SAN ONOFRE'S STEAM GENERATORS: SIGNIFICANTLY WORSE THAN ALL OTHERS NATIONWIDE

JULY 11, 2012

ARNIE GUNDERSEN, MENE
FAREWINDS ASSOCIATES
BURLINGTON, VERMONT, USA

REPORT COMMISSIONED BY FRIENDS OF THE EARTH

Figure 1

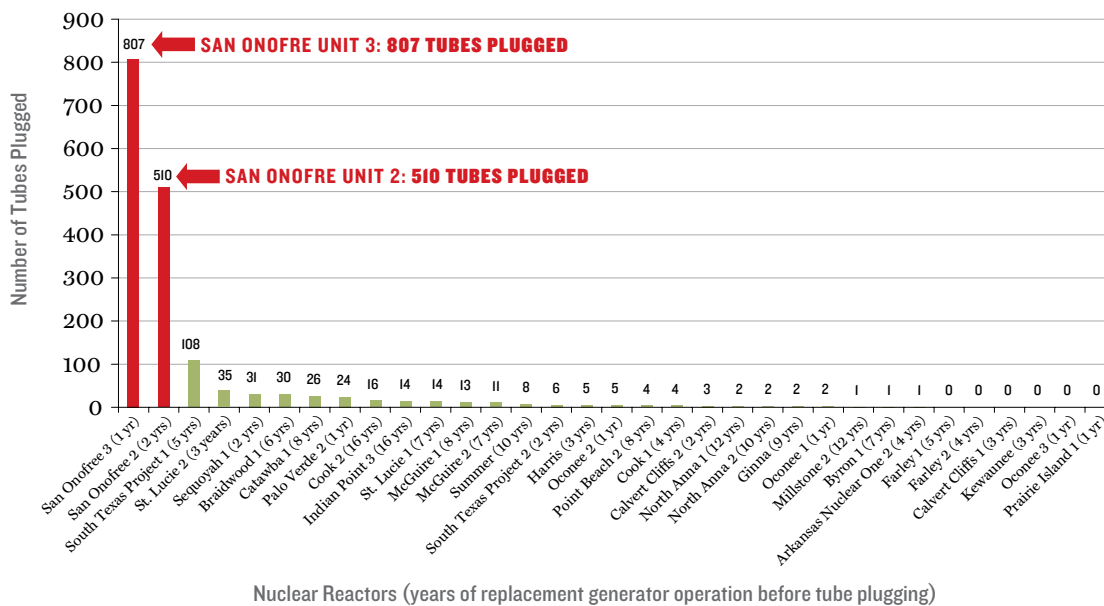
As evidenced in Figure 1, Edison has plugged 3.7 times more tubes in its San Onofre Units 2 and 3 replacement steam generators than the nationwide total of all plugs inserted in all the remaining replacement steam generators in all US nuclear reactors. Moreover, the NRC and Edison have not openly informed the public about the magnitude of tube generator plugging at San Onofre compared to the remainder of U-tube damage at other US reactors.

Even a casual overview of the data presented in Figure 1 shows an alarming difference at San Onofre in comparison to other operating US nuclear reactors. The minor differences between the replacement steam generators at San Onofre Units 2 and 3 are inconsequential when those steam generators are compared to replacement steam generators at all other US nuclear power plants.

More tubes are plugged in the replacement steam generators at ***EITHER*** San Onofre Unit 2 or Unit 3 than the total number of plugged tubes at every other replacement steam generator in every nuclear plant in the US.
